Subject: Virgil C. Summer Nuclear Station
Docket No. 50/395
SER - Confirming Issue 1.7.13 (1)
Degraded Grid Voltage

The attached change to FSAR Chapter 8 provides the information requested by Mr. Om Chopra regarding degraded grid voltage. This should provide sufficient material to resolve SER Issue 1.7.13 item 1. This material will be included in the next FSAR amendment.

SOUTH CAROLINA ELECTRIC & GAS CO.
VIRGIL C. SUMNER NUCLEAR STATION
 7.2 kV Bus IMA-TDB
 Undervoltage Relaying
 Figure 8.3-06
 (GAT Dwg. C-203-010)

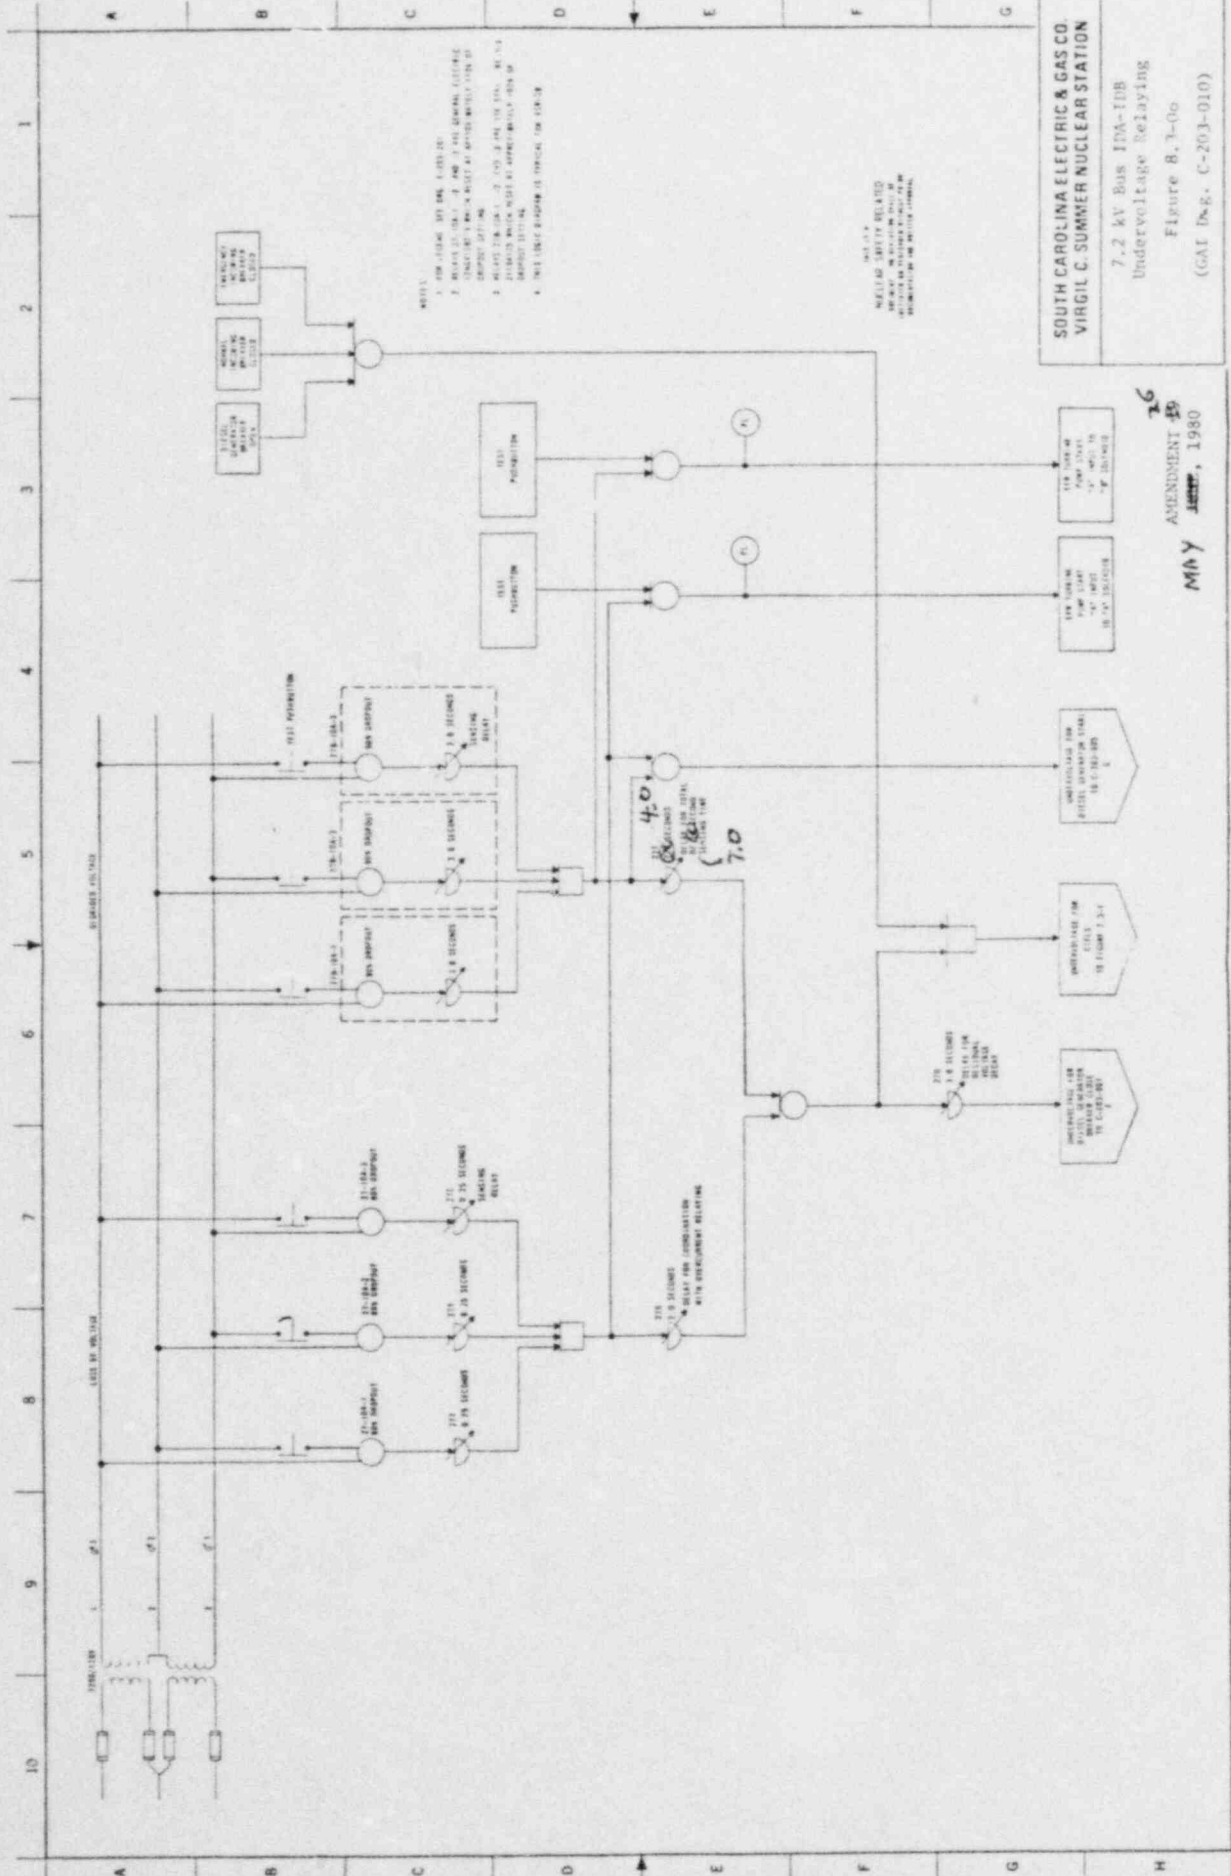
The 7.2 Kv ESF buses are each provided with three ~~loads~~^{loss} of voltage relays set at approximately 80 percent of the nominal bus voltage level and three degraded voltage relays set at approximately 91.34 percent of the nominal bus voltage level. Operation of a set of loss of voltage or degraded voltage relays will initiate a diesel generator start, a permissive for EFW turbine pump start, an engineered safety features load sequence operation and a permissive for diesel generator circuit breaker close. These operations occur in a timed sequence as outlined in Table 8.3-5. The logic of the controls are illustrated in Figure 8.3-0a.

As illustrated in Table 8.3-5 the 7.2 Kv bus circuit breakers are tripped ~~2~~⁴ seconds after the diesel generator is started on a degraded voltage condition as compared to ~~2~~⁵ seconds for a loss of voltage condition. The delay in tripping for a degraded voltage condition allows the bus to be energized during the time the diesel generator is coming up to speed. Therefore, with the degraded voltage condition the maximum dead bus time is ~~10.25~~^{SIX} seconds as compared to a 10.25 seconds dead bus time allowed for a loss of voltage condition.
